City of Sugar Hill Planning Staff Report VAR-18-002

DATE:January 30, 2019; Updated 2/6/2019TO:Mayor and City CouncilFROM:Planning Director ASUBJECT:Variance Request VAR 18-002431 Brogdon Road

2018\0813\CD\18~0813 Variance Site Pian 11×17.4wg Dec 20, 2018 - 7:3

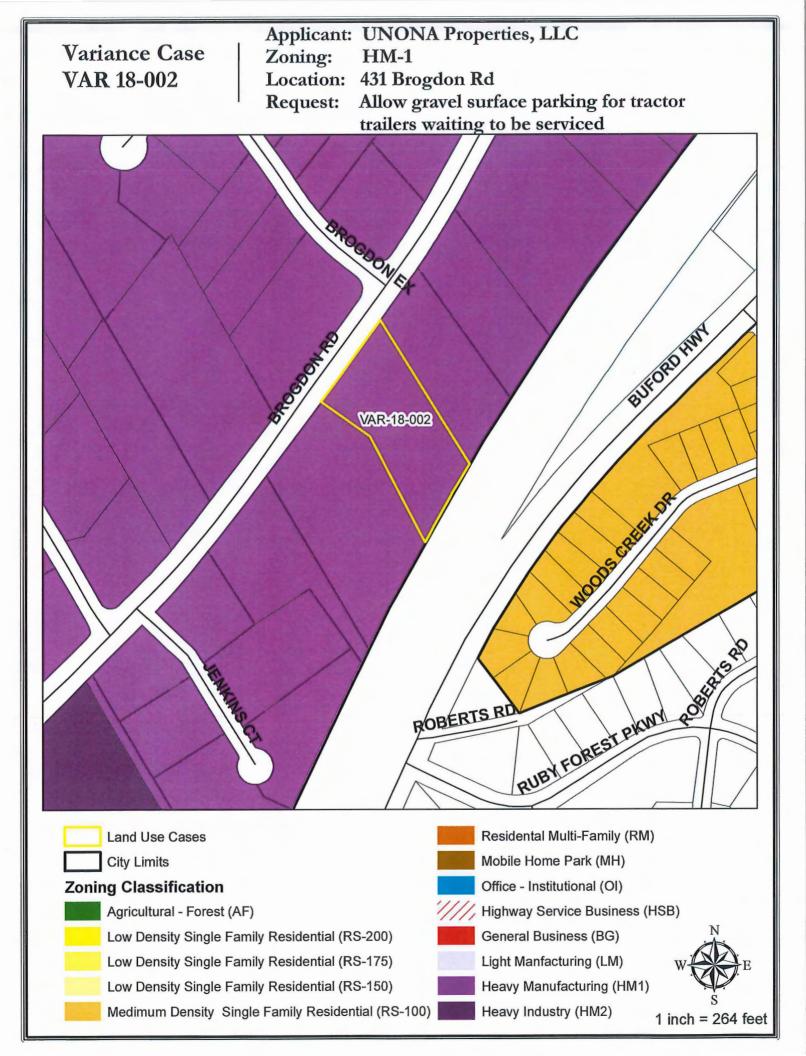
Denial. Evaluation of the variance criteria does not fully support a recommendation of approval. However, with the following conditions **approval** may be warranted:

- 1. Gravel parking shall be allowed only in the area delineated on the attached site plan labeled "Exhibit 1" *for a maximum of three years from date of approval.*
- 2. The gravel parking area shall be:
 - a. Maintained to a uniform depth of at least eight (8) inches of #57 stone or other approved gravel base with concrete vertical curbing around the perimeter.
 - b. Kept free of debris, weeds and uneven holes or depressions; and
 - c. Graded to ensure rain water runoff flows into a detention facility as designed.
- 3. Provide a permanent dust control plan prepared by a certified erosion control professional prior to issuance of a site development permit.

The applicant is proposing to construct the gravel surface parking area with eight inches of #57 stone contained by steel edging and an eight foot high security fence around the perimeter of the operations area. The fence is to include opaque mesh screening material.

Yes. The proposed parking surfaces should not be easily visible from the road or neighboring properties and are directly adjacent to a railroad right of way. The subject property also sits directly beside a property originally developed as an office use which has been repurposed as a private school. The side of the school facing the subject property appears to be primarily for service and incidental access.

No. The standard improvements required for off street parking lots are generally intended to protect the aesthetic and environmental integrity of areas where parking facilities are located. Properly developed and maintained, the visual and environmental impacts of this proposed gravel parking lot could be little to none for surrounding properties and passersby. Except for visitors and users of the subject property it is possible that no one would be able to observe if the rear parking areas were constructed of gravel or concrete. Additionally, conditions offered by staff are designed to mitigate the potential impacts and preserve the intent of the regulations should the City Council wish to consider an approval.
